PROJECT: One Queensridge Place (Condo Towers) - Update #2

CITY OF LAS VEGAS		DATE:
INTER-OFFICE MEMORANDUM		August 27, 2012
TO: Land Development Services Department of Public Works		FROM: Albert Sung, P.E. Flood Control Project Engineer Department of Public Works
SUBJECT:	Drainage Study for:	
	One Queensridge Place (Condo Towers) – Update #2	
Cross Streets:	SWC of Alta Drive & Rampart Boulevard	
File Number:	F:\Depot\DSMemos\DS3746E.doc	
Parcel Number:	138-32-210-001 & 138-31-312-002	
Zoning Action:	ZON 4205 & SDR 4206	
FEMA Flood Zone	YES	NO X
Proposed Storm Drain	YES X	NO
COPIES TO:		Nevada by Design
		Queensridge Towers, LLC
		Bart Anderson, P.E., DevCo

**ADDENDUM #1 TO THE
UPDATE LETTER #2 TO THE
TECHNICAL DRAINAGE STUDY**

RE: Addendum #1 to the Update Letter #2 (#DS3746E) for One Queensridge Place Drainage Study #DS3746D

SHEET NO.:
C4.03
SHEET 18 OF 33
DRAWING NUMBER
1074 4883 ©2000

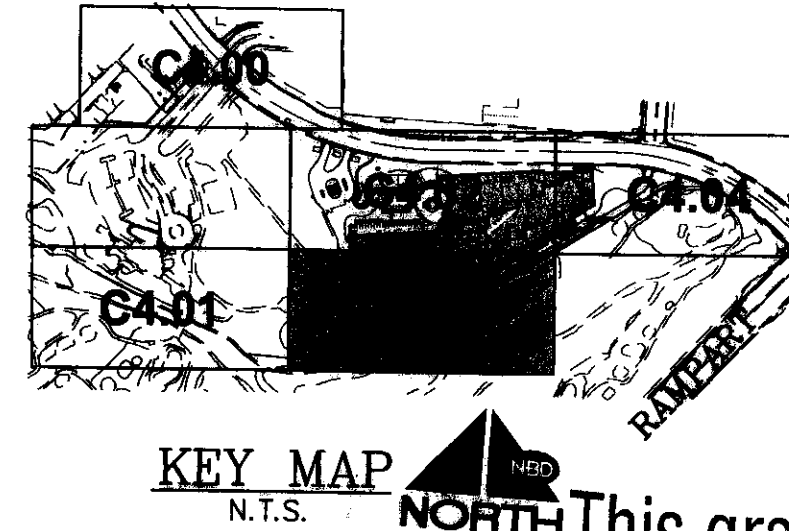
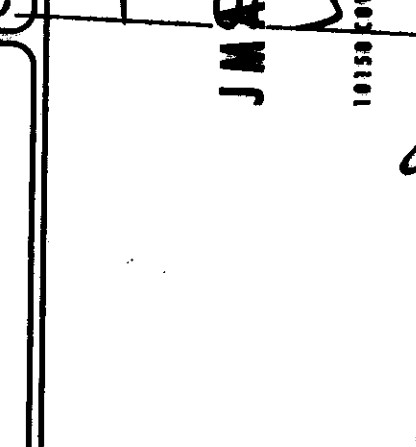
Per the contour lines as shown on the plan, it appears that the original approved location of the trench inlet captures flow from the north in the driveway which prevents any flow from inundating the tower first floor I basement.

- Sheet C4.03:** The as-built shortened storm drain with a trench inlet at the west side of the **Condo Tower II** appears to be not adequate for the following reason:

Per the contour lines as shown on the plan, it appears that the original approved location of the trench inlet captures flow from the north in the driveway which prevents any flow from inundating the tower first floor / basement.

Per a recent meeting with yourself and Frank Mendoza from One Queensridge Place in regards to the trench inlet drain Mr. Mendoza had clarified that the trench inlet drain had been installed per the approved plans. The revised plans that had been submitted had been based upon as-built drawings that had been provided by the Contractor. Upon reviewing these and the field conditions it has been determined that in fact the trench inlet drain was built per the approved plans.

Attached is the approved Sheet C4.03 and it correctly reflects that there is no change. As part of this Update Letter the only change in regards to the drainage is the storm drain line along the south access road that was shortened in length (see Sheets C3.02 & C10.00).
